# PSE and PD State Diagrams

**Andy Gardner**

**Linear Technology Corporation**

# Proposed PD detection state diagram

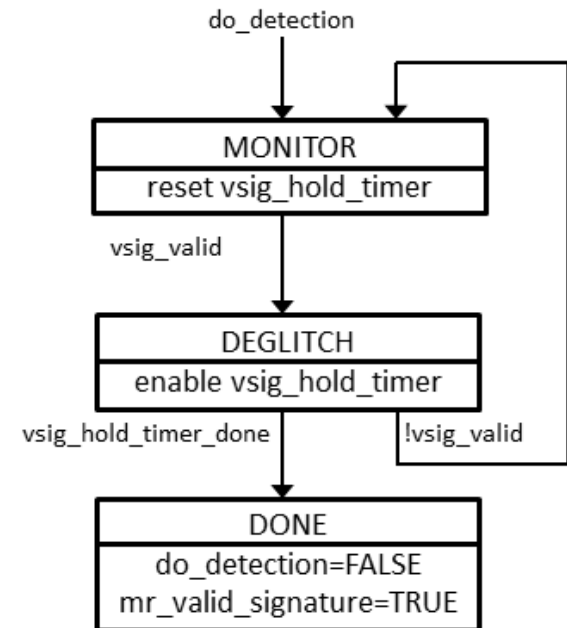
- PD detection is performed during the START\_DETECTION state and makes the DETECT\_EVAL state redundant.
- tdet\_timer sets a timeout on the do\_detection function and bounds the upper value of  $C_{PD}$  during detection.
- vsig\_valid indicates when the PD signature voltage is in the range of  $V_{good}$  in Table 104-4.
- vsig\_hold\_timer de-glitches vsig\_valid.
  - What is a reasonable de-glitch time?

# D1.1 PSE State Diagram vs. Proposed Simplified PSE State Diagram

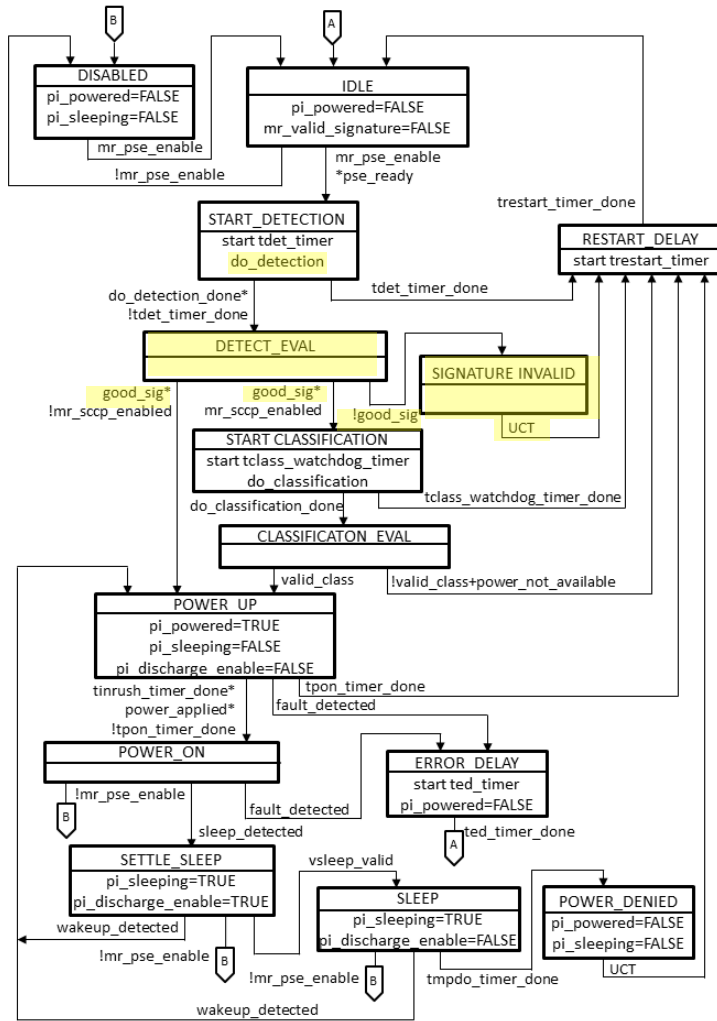
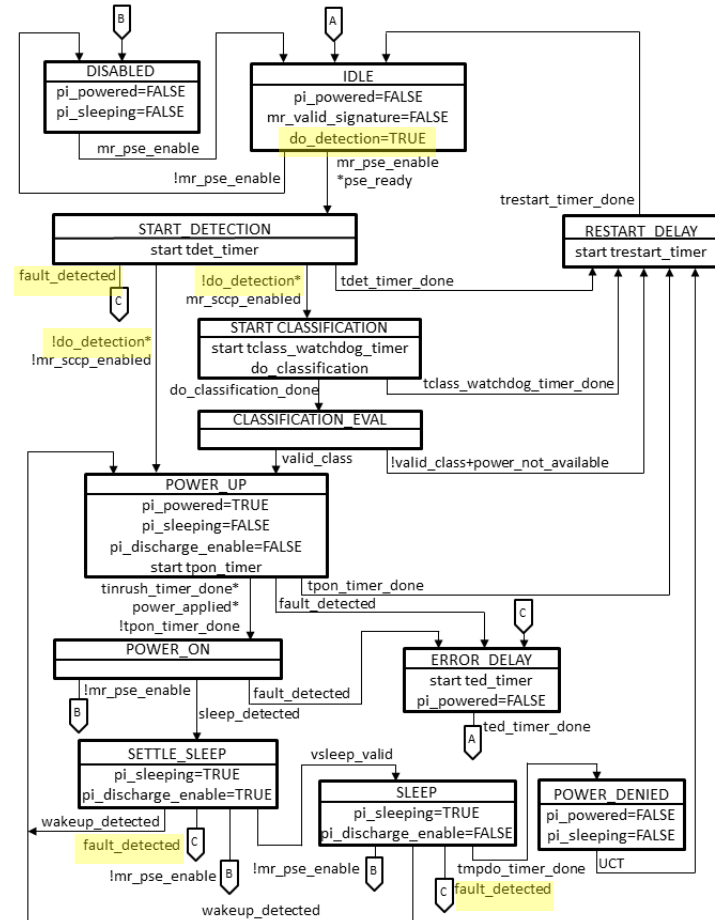
- Simplification of the detection related states is possible in the PSE state diagram.
  - As is, the SIGNATURE\_INVALID state is superfluous and the !good\_sig arc to it can be eliminated.
  - The do\_detection function can be replaced with a simple detection state diagram.
  - Given the simple nature of detection, the DETECT\_EVAL state appears to be redundant.
